## ANN ARBOR HISTORIC DISTRICT COMMISSION

### Staff Report

**ADDRESS:** 415 West Jefferson Street, Application Number HDC15-059

**REPORT DATE:** May 13, 2015

**PROPOSED SIDE ELEVATION (WEST)**

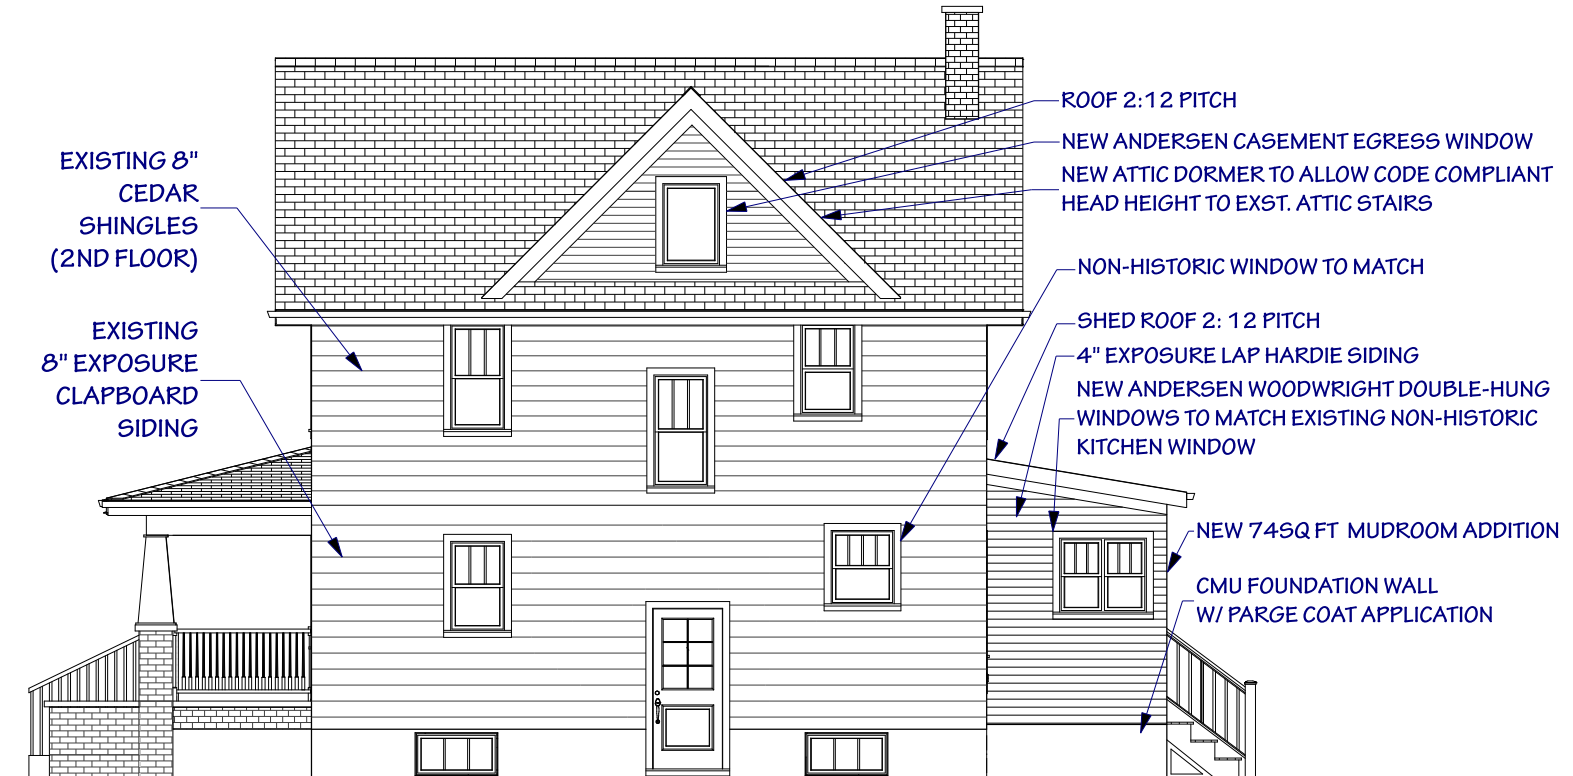
3. The gabled dormer will allow an existing staircase from the second floor to the attic to meet headroom requirements, and provide a casement egress window. It does not interfere with the eave or ridge of the roof. Cladding is 4" cementitious lap that matches the mudroom addition. The dormer will be visible from the public right of way, but the design is not obtrusive and is compatible with the house. A small dormer is an appropriate modification to allow the homeowners to take advantage of a large amount of attic space.

**PROPOSED BACK ELEVATION (SOUTH)**

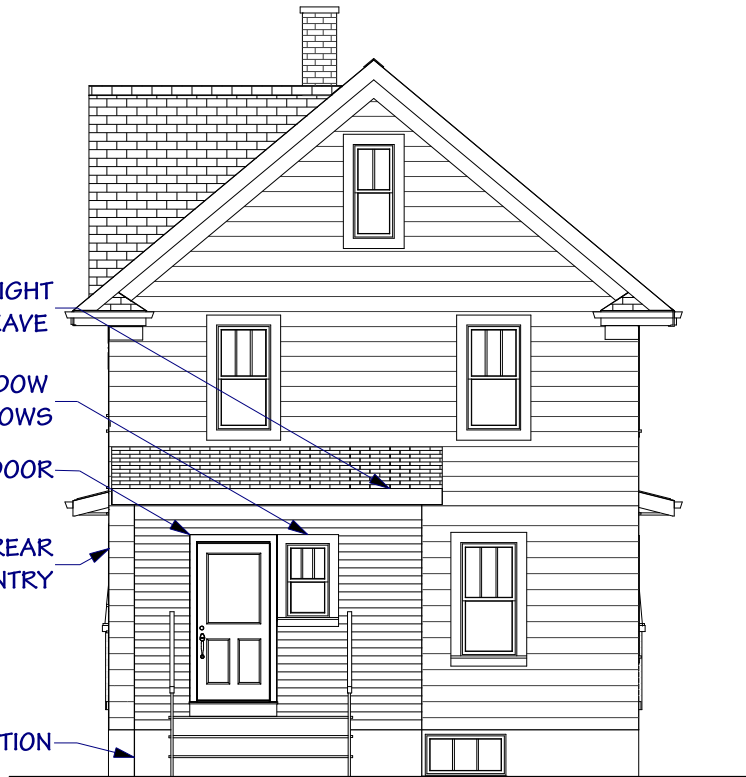
2. The mudroom, which also contains a half-bath, is 7'6" deep by 12' wide. It encapsulates the existing backdoor, which is not original, though the opening most likely is. The addition does not interfere with any other openings on the rear of the house. The mudroom is clad in 4" exposure cementitious lap siding, and the windows are Andersen vinyl-clad three-over-one doublehangs that match an existing non-original kitchen window. The height of the eave matches the existing covered porch eave, and the west wall is inset 13" from the original corner of the house. The non-original back door would be relocated onto the addition, and the new stairs and guardrail would be cedar. The addition's size, placement, design and materials are compatible with the house and neighborhood, and will not be visible from the street or sidewalk.

**PROPOSED SIDE ELEVATION (EAST)**

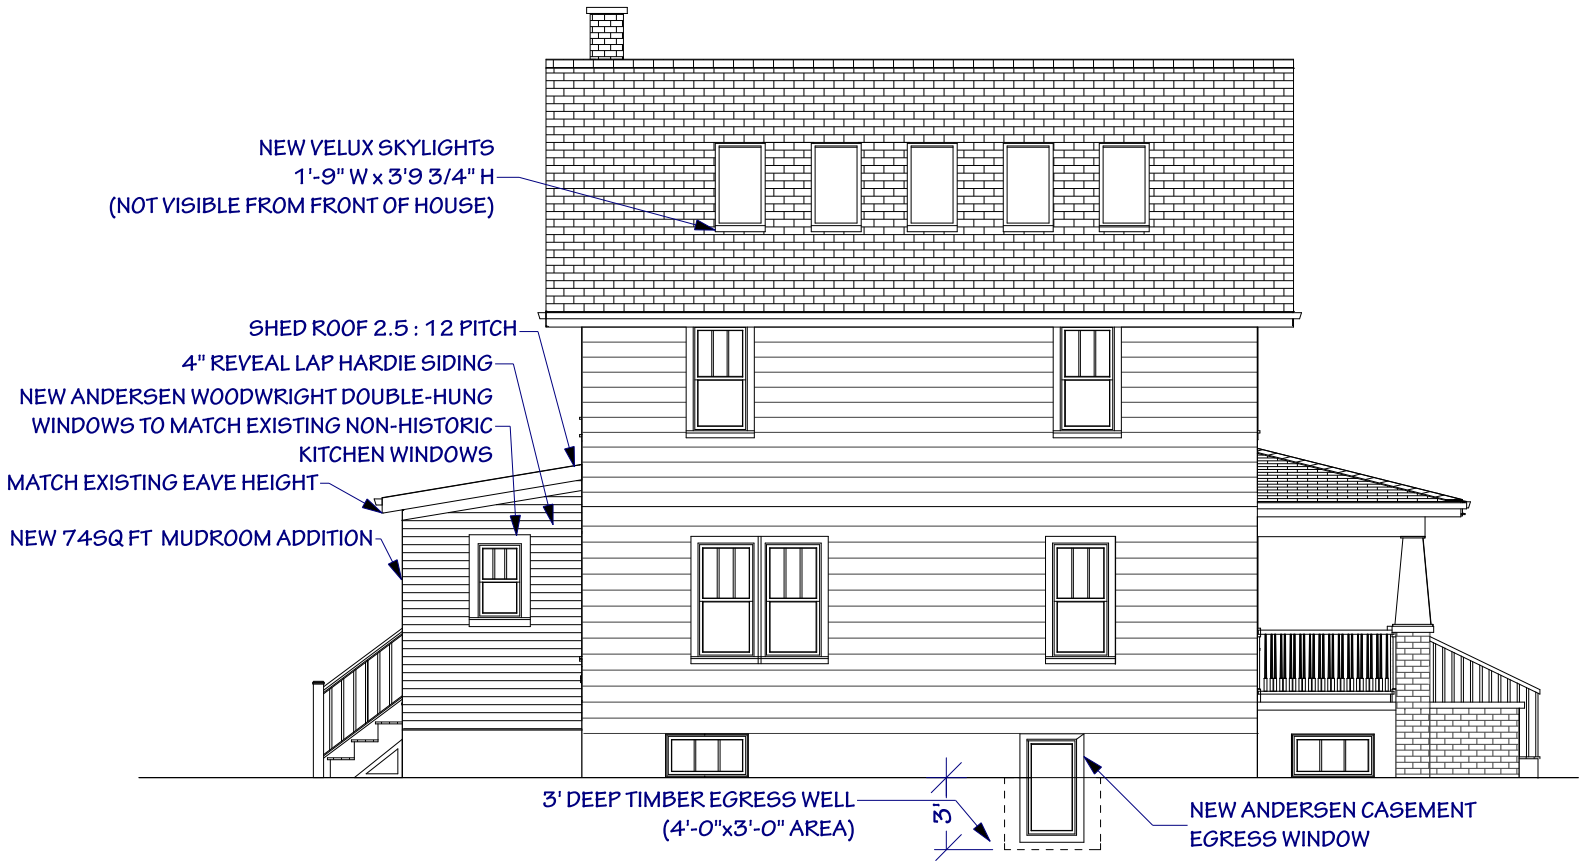
4. The five skylights are Velux QPF low-profile (though staff could not find the actual height of the skylight above the roof plane) in a dark color. Each skylight is approximately 1'9" x 3'10". The height and pitch of the roof, combined with the close proximity of the next-door neighbor's house assure staff that the skylights will not be visible from the street or sidewalk. Therefore, the use of skylights to bring light into an underutilized space is appropriate.

5. The basement egress window is on the east elevation and matches the width of an existing basement window. There is another basement window closer to the rear of the house, but the location of the furnace and water heater between it and the finishable space makes it unsuitable for egress. The window well would be 4' wide by 3' deep and built of wood timbers. An Andersen 400 series casement window that is 2'4" by 4' would be installed.
